## MEMORANDUM

**Reference:** Case No. PD-270-RBN, The Avenue at Denton Tap, a zoning change request from Commercial to a Planned Development to allow 29 multifamily units and 8,575 square feet of office/retail uses on 1.77 acres of property located at the northwest corner of Southwestern Boulevard and South Denton Tap Road.

**STAFF REPORT**

**CASE NO. PD-270-RBN, The Avenue at Denton Tap**

Site Plan

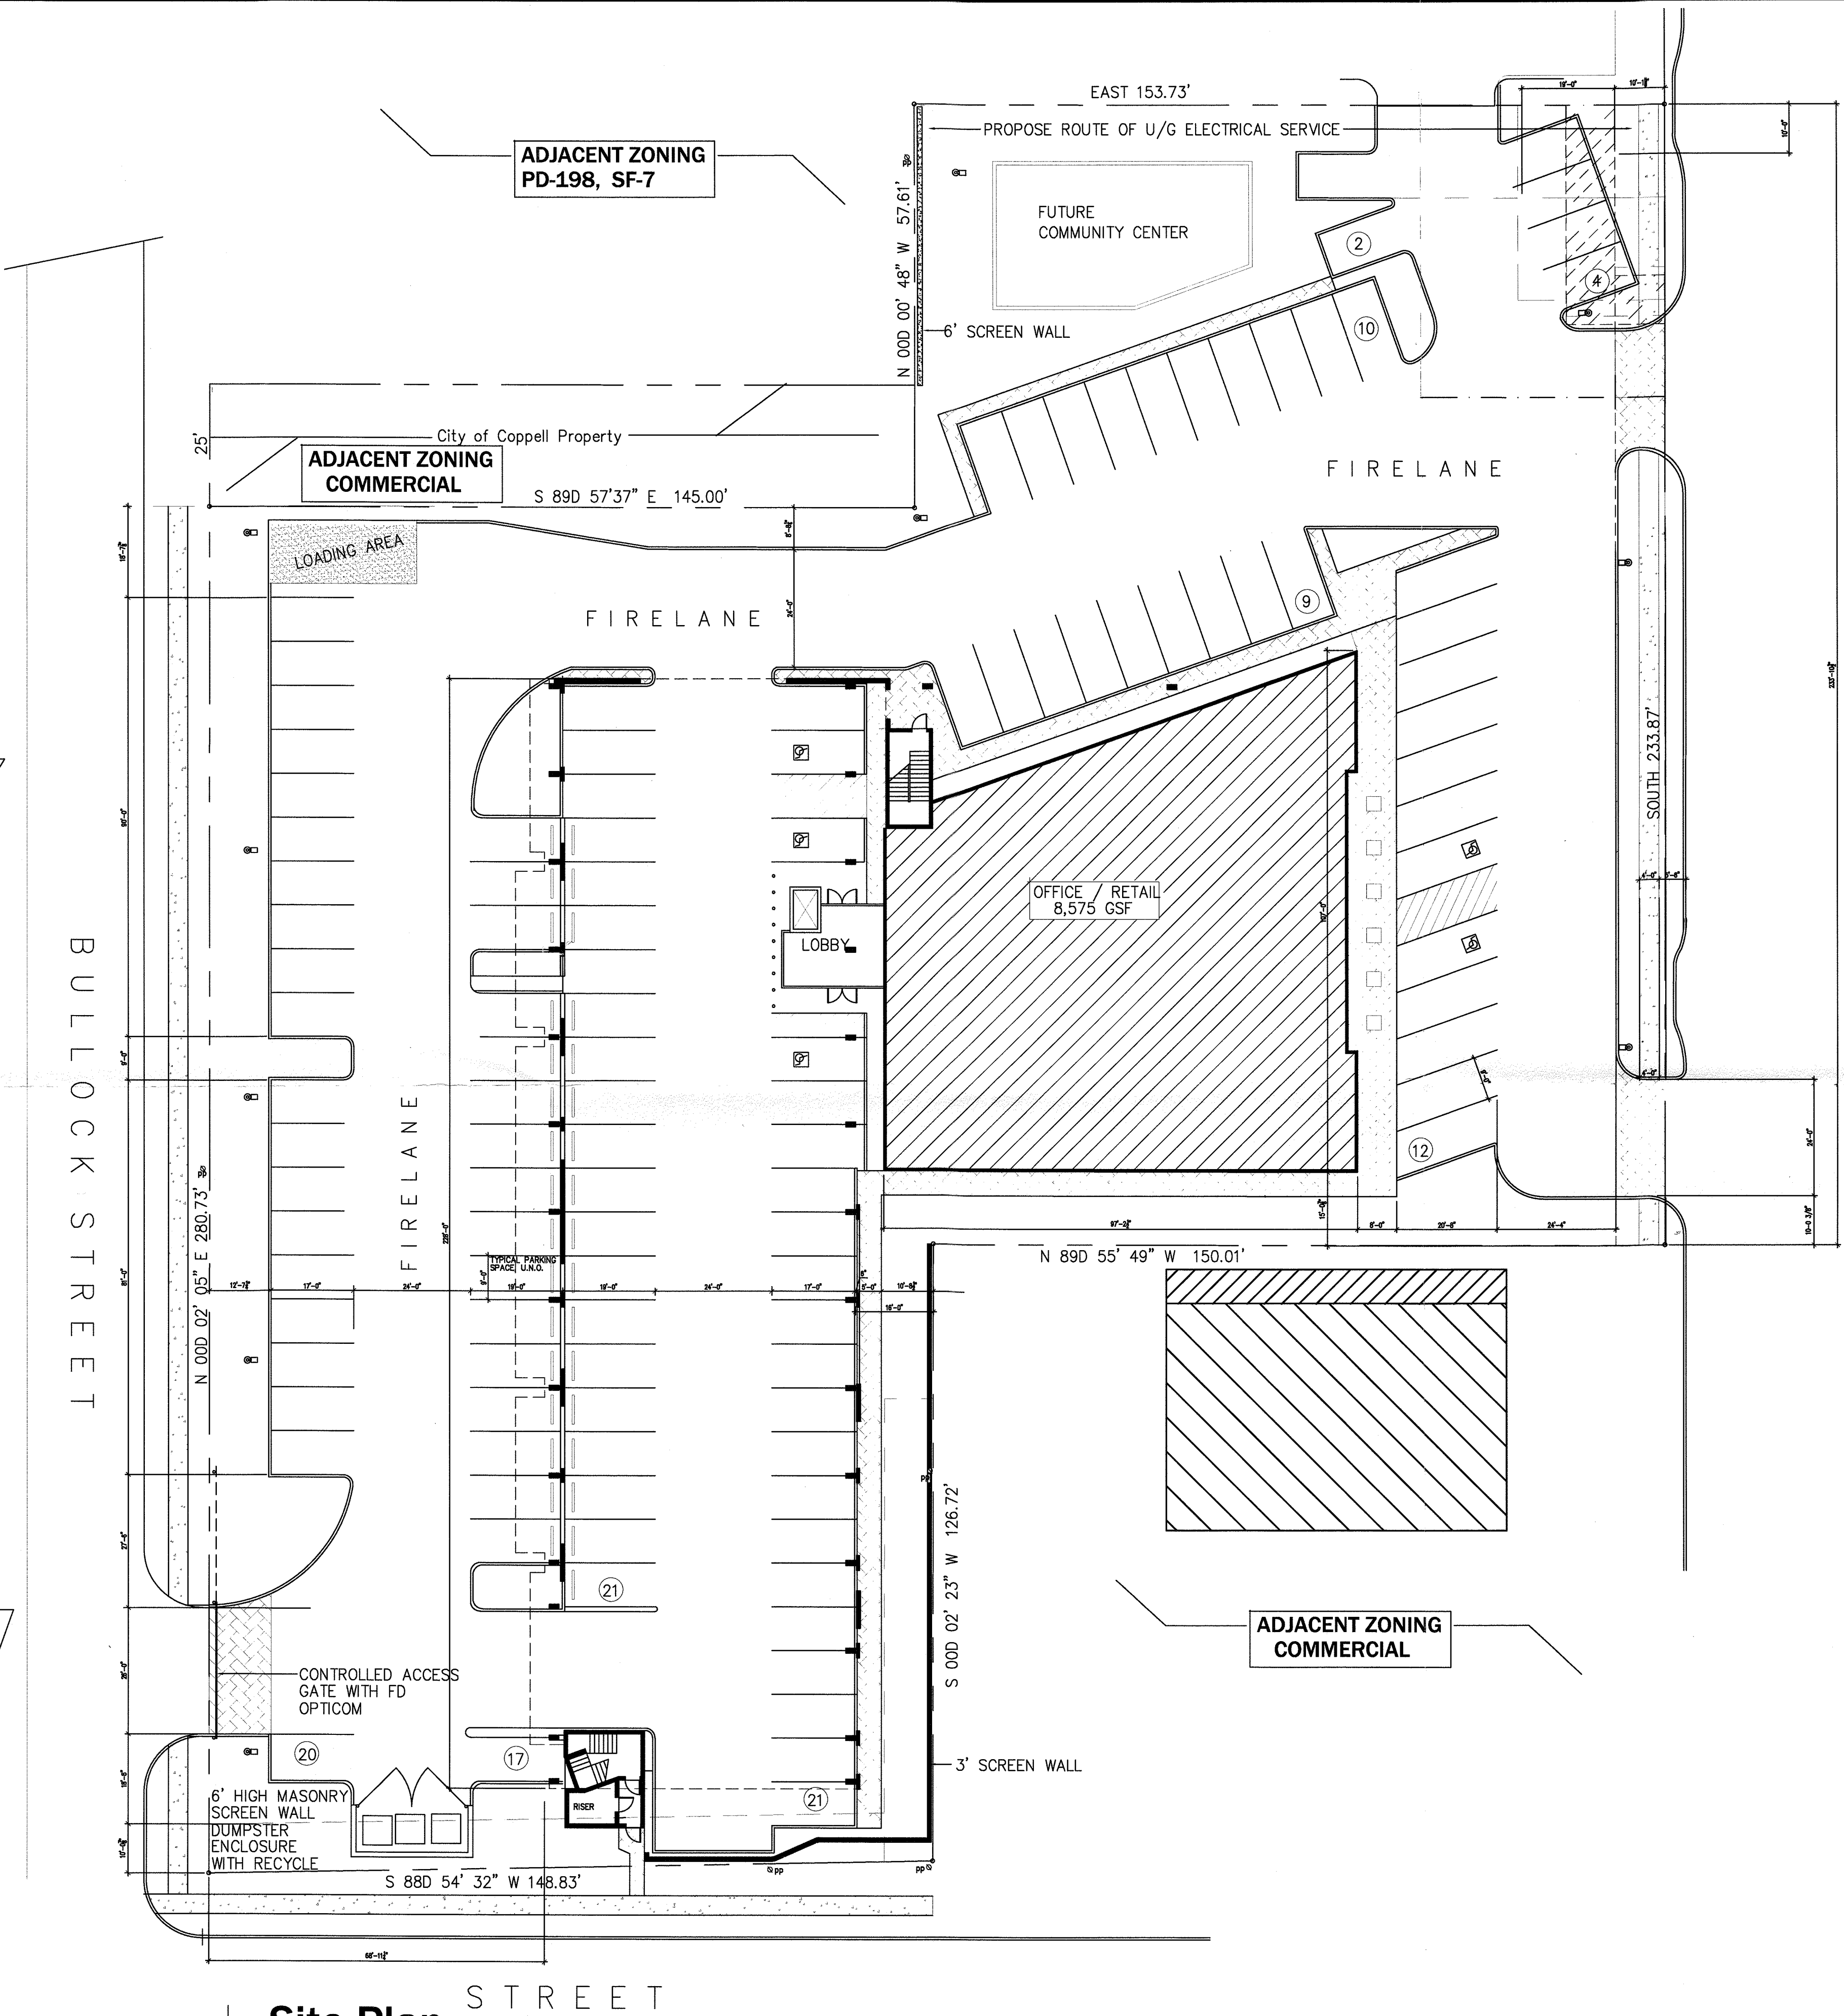
This building is proposed to be setback 63 feet from Denton Tap Road and 69 feet from Bullock Street. It is recommended that the 69-foot setback be supported to keep a buffer and transition from the residential neighborhood into the proposed higher intensity mixed use development.

A 36-foot setback is proposed along the northwest property line, which is adjacent to a 25-foot right-of-way providing a greater separation from the residential neighborhood. The main building is 63 feet from the Denton Tap Road right-of-way where the RBN District calls for a building to be no more than 15 feet from the lot line. Staff can support this deviation, as both a drive and parking are warranted for the office/retail use.

This proposal exceeds the 116 parking space requirement by providing 119 spaces. Both the *Comprehensive Plan* and the RBN District encourages structured (garage) parking. In this development 41 of the 119 spaces are contained within the structure. It is recommended that this parking area on the first floor be better screened with a three-foot masonry wall incorporated into each façade and this has

been listed as a condition of approval. Beyond the structured parking are 41 spaces in a parking lot. This area is proposed to be screened with a 12 foot wide landscaped area east of Bullock Street. The proposed off-street parking and drive (similar to a slip street recognized in the Comprehensive Plan). The proposed parking located on the Denton Tap Road side is angled with a one-way drive to provide an opportunity for streetscaping without actually having dangerous on-street parking on Denton Tap.

1 LANDSCAPE PLAN  
SCALE 1"=20'

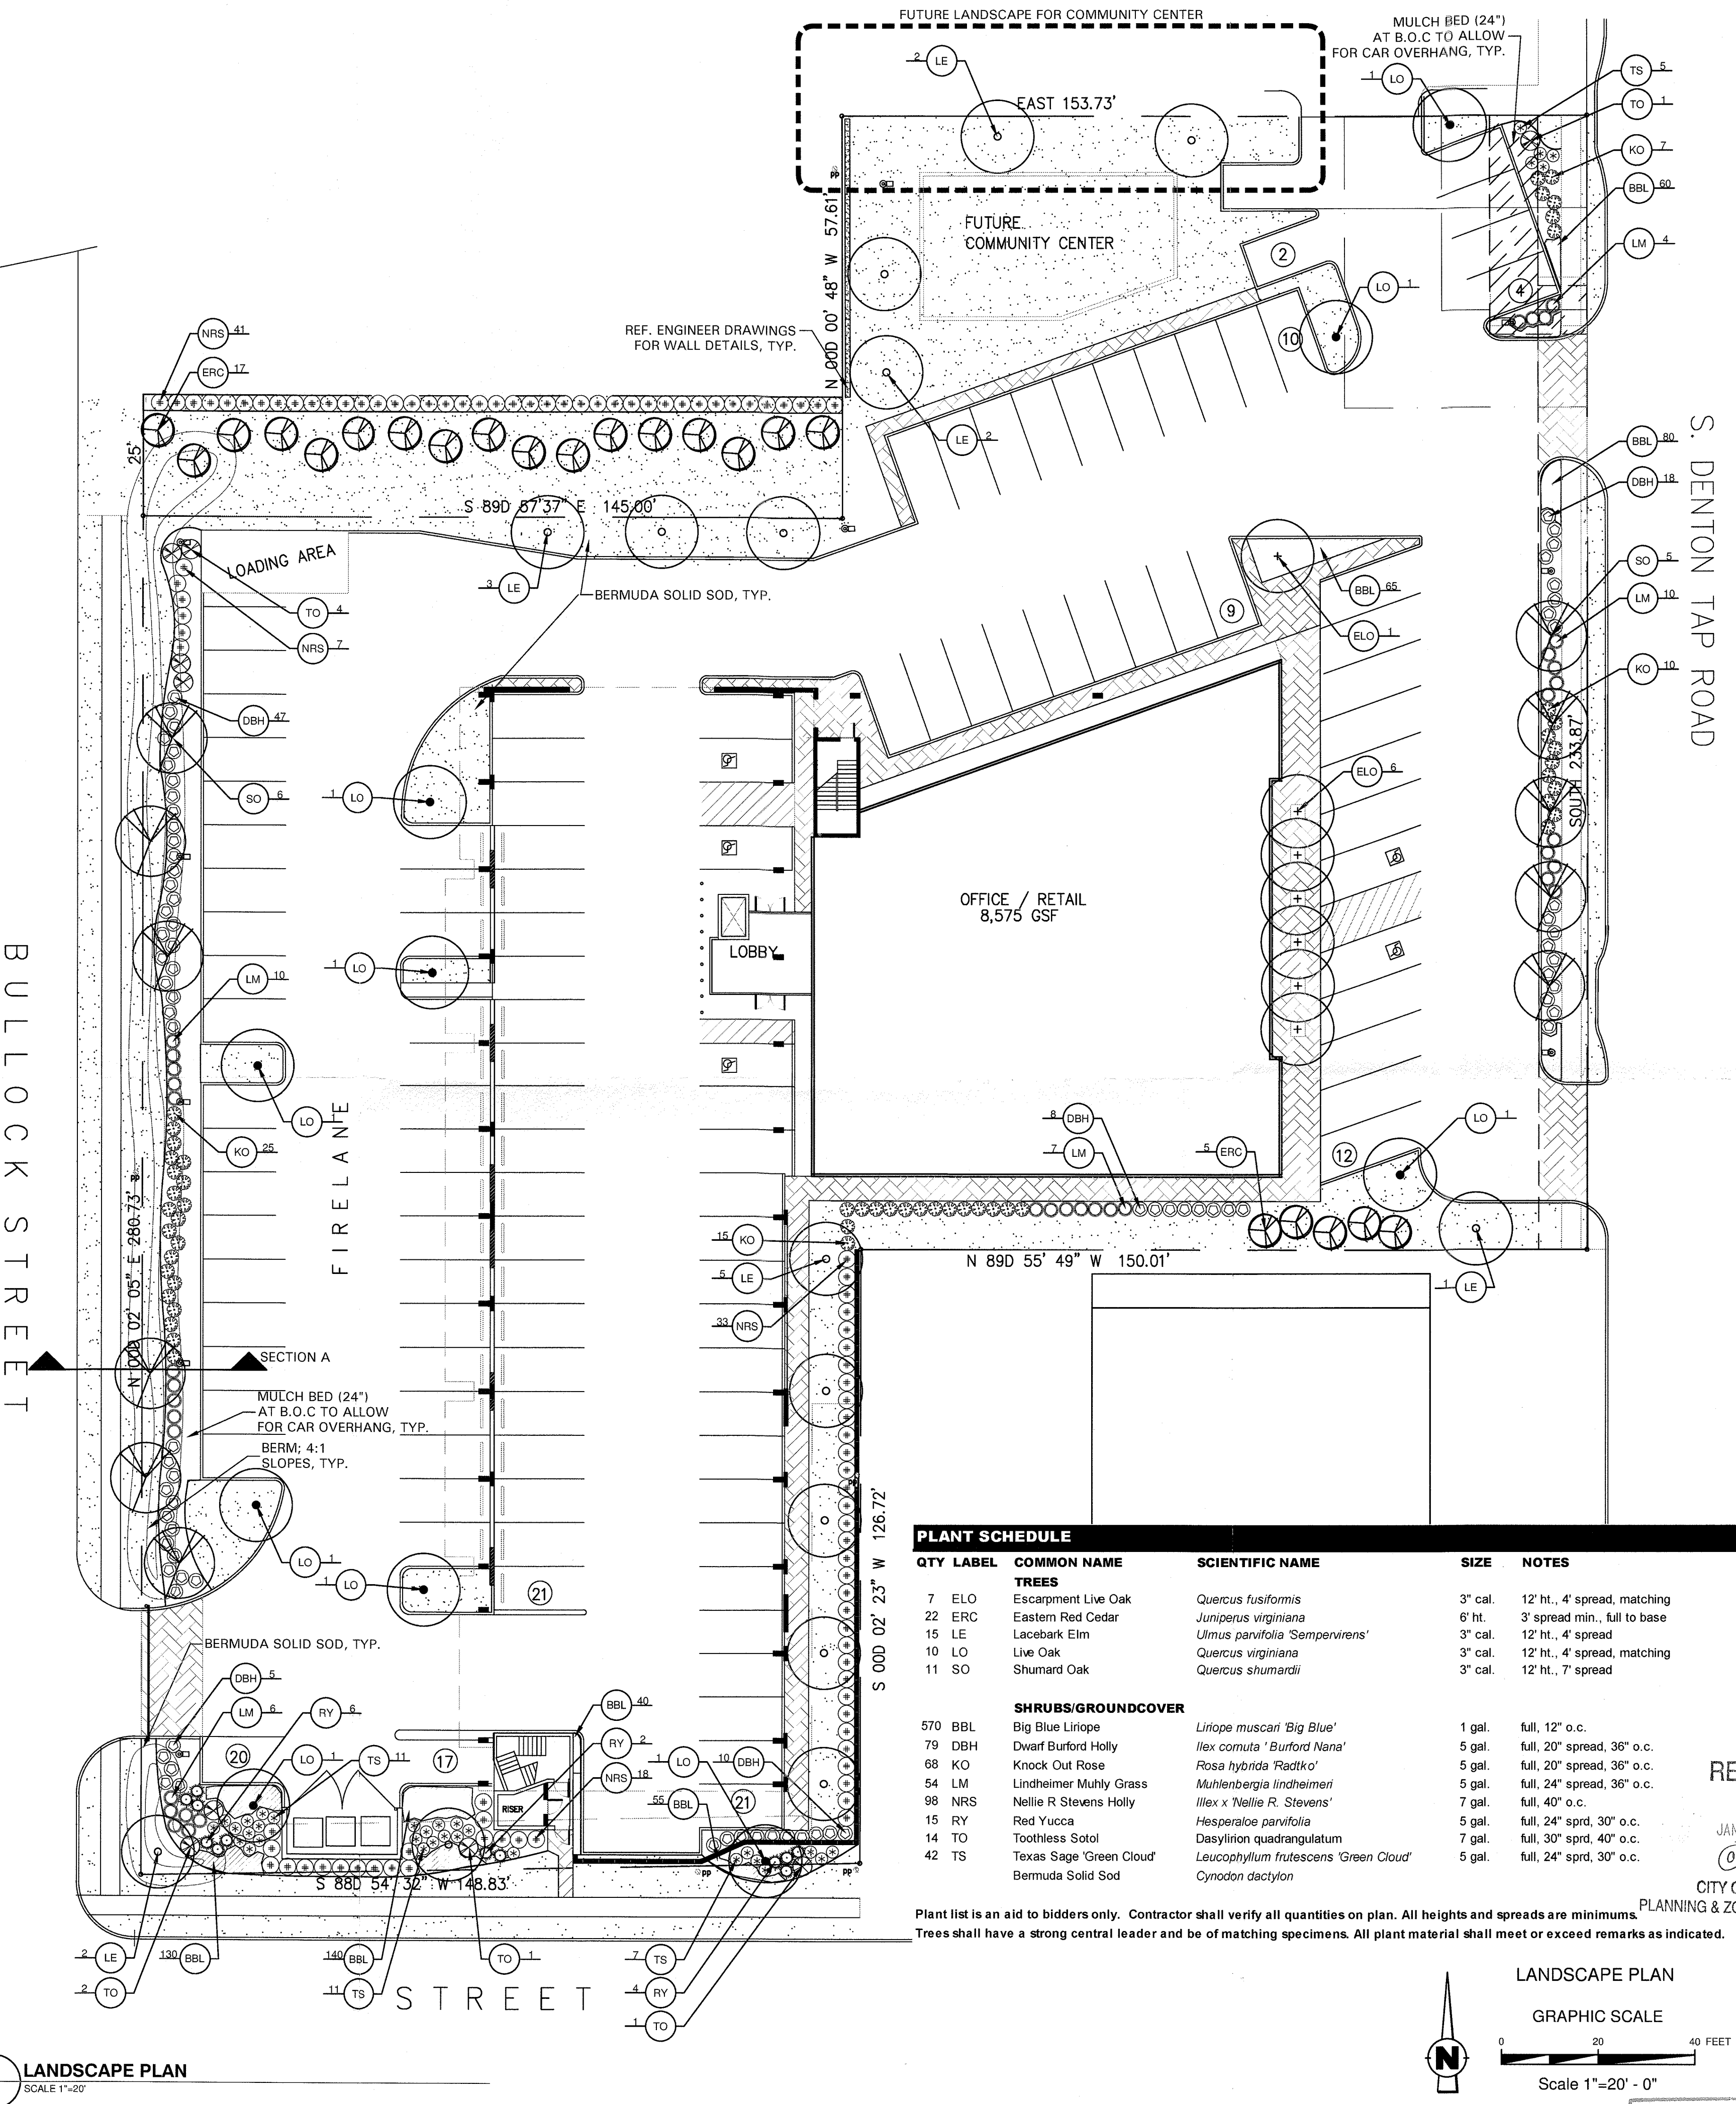
The landscape areas within a RBN District are different than the typical business zoning districts where under the RBN, a minimum 15% open space/common area is required. The proposal indicates that 17% has been provided. The streetscaping of the retail/office area is adequate where street trees are being provided. However, additional landscape islands are being recommended in the parking lot where there is no structure over the parking. Not more than 15 parking spaces are typically permitted without an island and one island is required at the end of each parking row; therefore, three islands are recommended. Also, the applicant has agreed to add an evergreen area of landscaping (containing Nellie R. Stevens and Eastern Red Cedars) to the 25 foot right-of-way strip located northwest of the property to better buffer/screen this proposal from the existing residential neighborhood.

| 8.  | Include three 150-square-foot landscape islands with an overstory tree within the proposed surface parking area where not under the structure. No more than 15 spaces are typically permitted without an island and one island is required at the end of each parking row. |
| 12. | Label the 25-foot right-of-way northwest of the site as City of Coppell Property. Include Eastern Red Cedars and Nellie R. Stevens south of the existing fence.  |
| 15. | Revise the Landscape Plan to include interim and future landscaping for the "Future Community Center" portion of the site.   |

**01 Elevation at Sliding Gate**  
Scale: 1/4" = 1'-0"

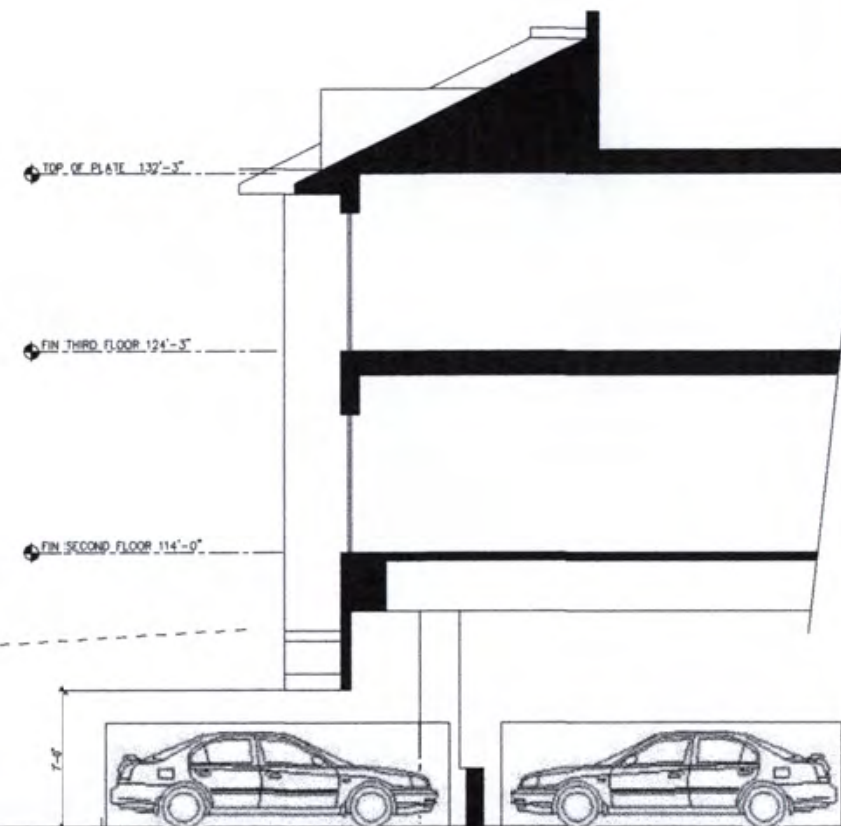
| 16. | Include a gate with controlled access (include opticom for Fire Department) at the southwest access point off of Bullock.  |
